DATE: August 17, 2023; 10:45 am – 12 noon

WORK IN PROGRESS: Cutting out of existing mortar joints

Photo #1: Replacement stone was laid at the arched head and west jamb of this second floor south facing window.

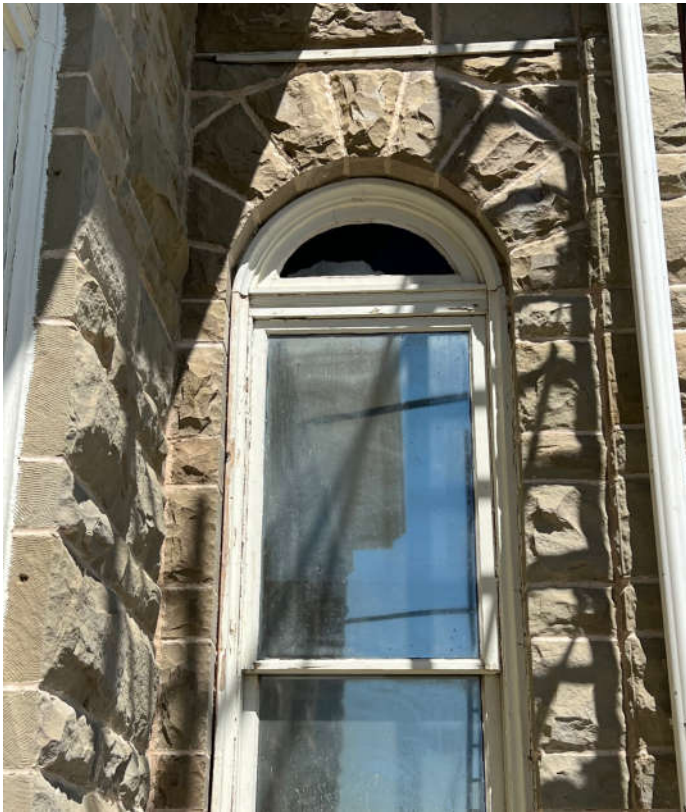
1. The cutting out and repointing of mortar joints is in progress. Most of the joints from the top of the walls to the second floor window sills have been repointed. (Re: Photo #6.)
2. On the south wall at the second floor window, the stones at the arched head have been replaced along with the stones at the west jamb. Backer rod, if required, and sealant will be used to fill the joint between the stone and the brick mould. The steel plate above the arch will remain in place; it may have been installed to serve as support for the arch below when the gutter was leaking, causing damage to the stone. (See Photo #1.)

Photo #2: A replacement piece of radiused stone moulding above the plaster sign was fabricated by Mountain Masonry. (Photo Source: Mountain Masonry)

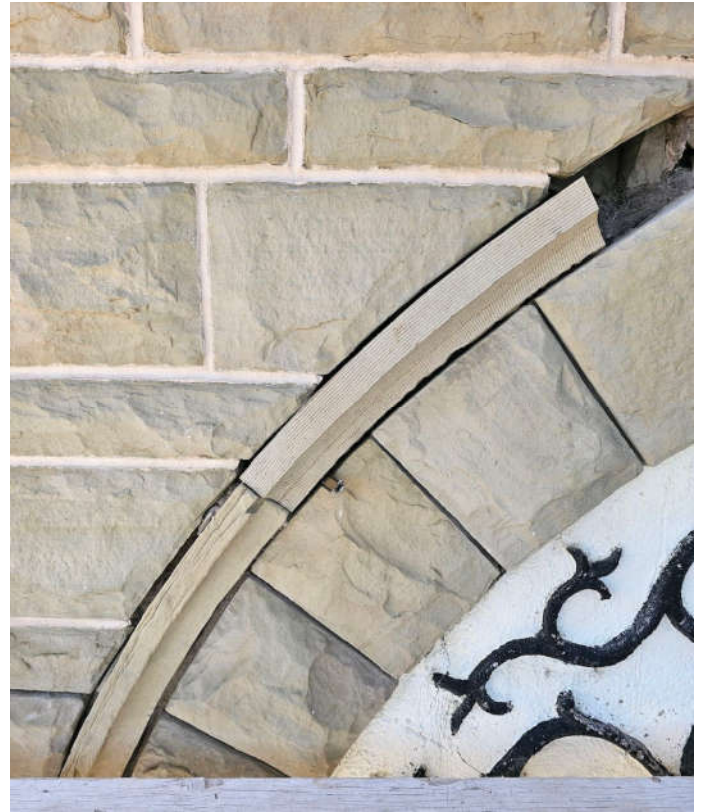
- d. Two stones that form part of the arch above the plaster sign were called to be replaced. They are in good condition and will be retained.
 - e. The decorative stone moulding that wraps the top of the stone arch above the plaster sign was found to be in poor condition; more stones require replacement than what was called out on the drawings. Consequently, all of the stones will be replaced. Mike had a replacement stone on site that he made; he placed it in the arch following the site visit. (Re: Photo #2.) The small, eroded stones below the third floor center window will also be replaced. (Re: Photo #4.)
